BUILDING PERMIT

Permit Number: 100814

has permission to Kitchen remodel & mudroom/master suite addition

AT 72 ELIZABETH ST Pearls Island - CP 087 N006001 **City of Portland**

FIGURE 10

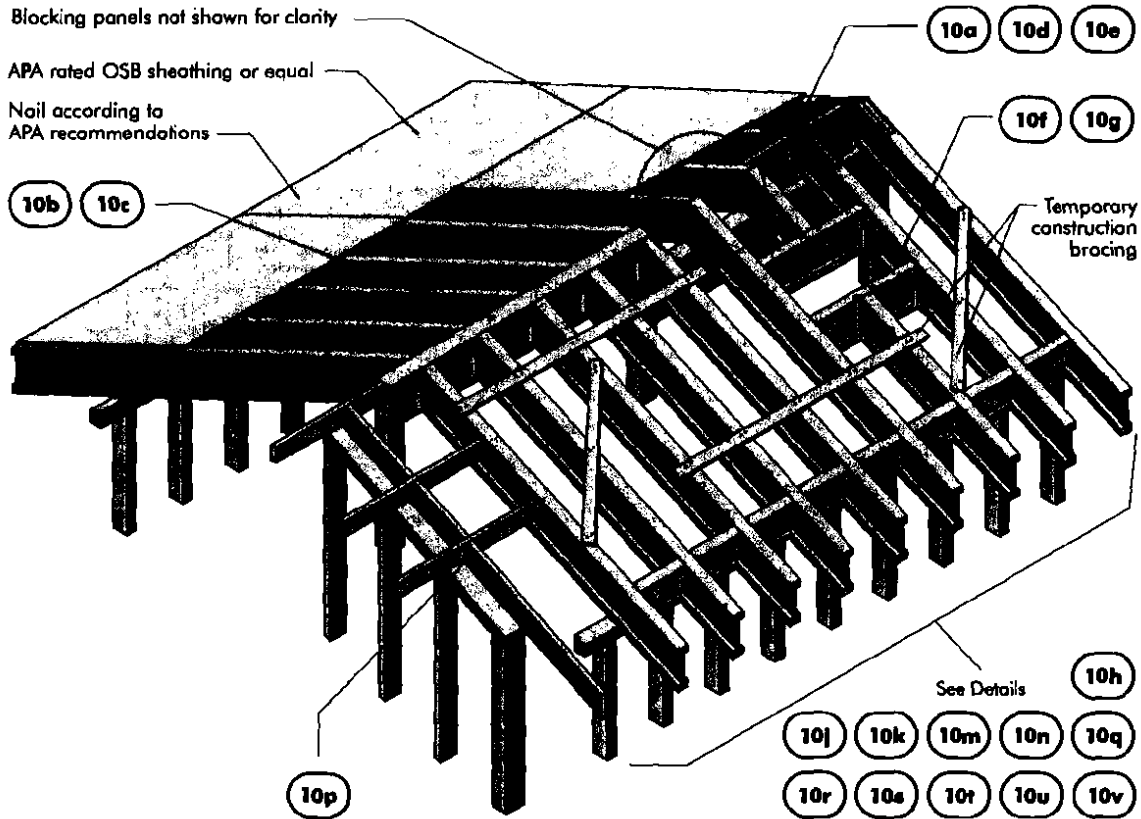
7/27/2010-jmb: Spoke with Rachel C. For details from review including tempered window at the 1st fl bath, FPSF design criteria per Sec. R403.3, master suite roof framing for the skylights, define removable ladder to the loft, and condition on the design for reduction of clearance to combustibles for the wood stove. She will submit.

Here is a link to some I-joist details. You will find roof details begin on page 17, and more specifically, the header details are noted on page 19, drawings 10f and 10g.
